RE: E20955.00 - St Cuthbert's RC Primary School - Pre Construction Info Pack

TITLE / DESCRIPTION:
TYPICAL STRUCTURAL DETAILS

WRD REF: E20955.00		SCALE AT A1: 1:10					
PROJECT	ORIG.	VOL.	LEVEL	TYPE	ROLE	No.	REV
E20955.00 - WRD-ZZ-ZZ-DR-S-200003							C02

4 DETAIL
BEAM BEARING DETAIL - 1
SCALE 1:10

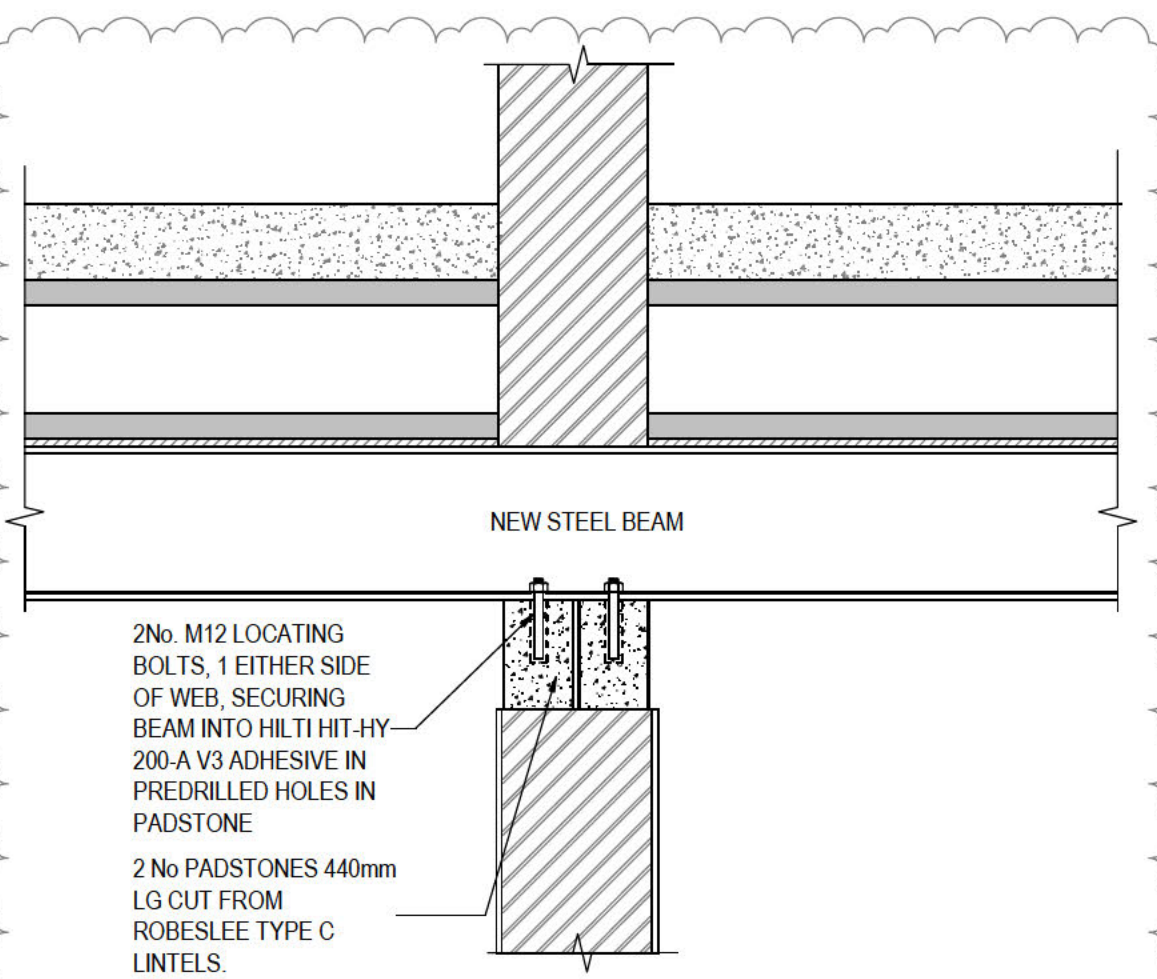
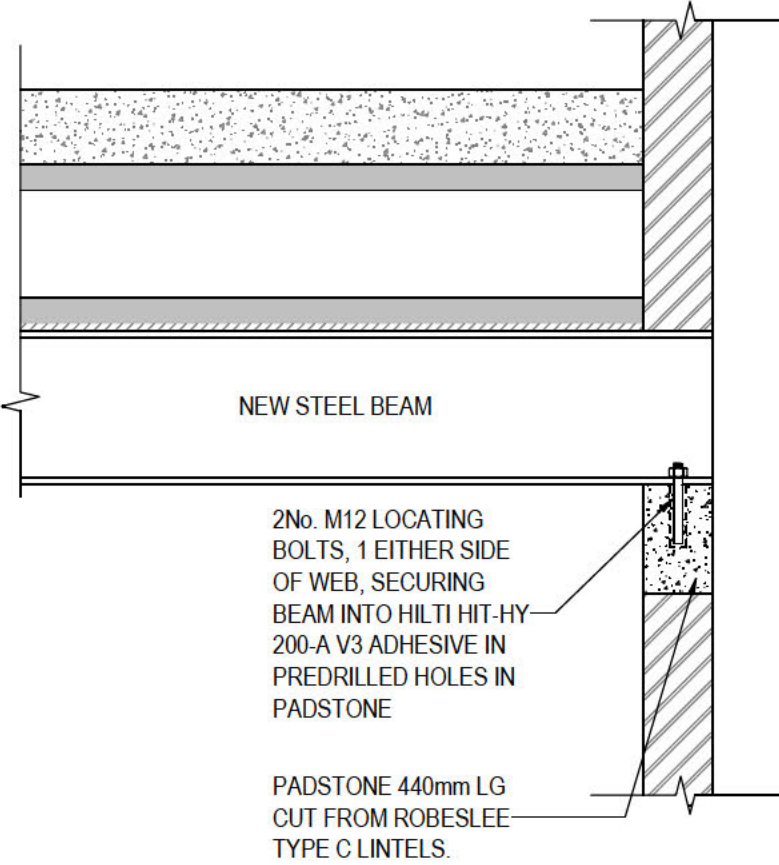
We were of the understanding the steelwork passing through the party wall on the ground floor and upper floor levels was not to be staggered which would reduce the opening to the party wall and a single 4.0Mtr steel would split the party wall.

Can you advise accordingly and amend.

Please find attached updated drawings as we discussed. We will follow up with a small update to the detail sheet to reflect the bearing between the classrooms not being staggered. Let me know if you require anything further.
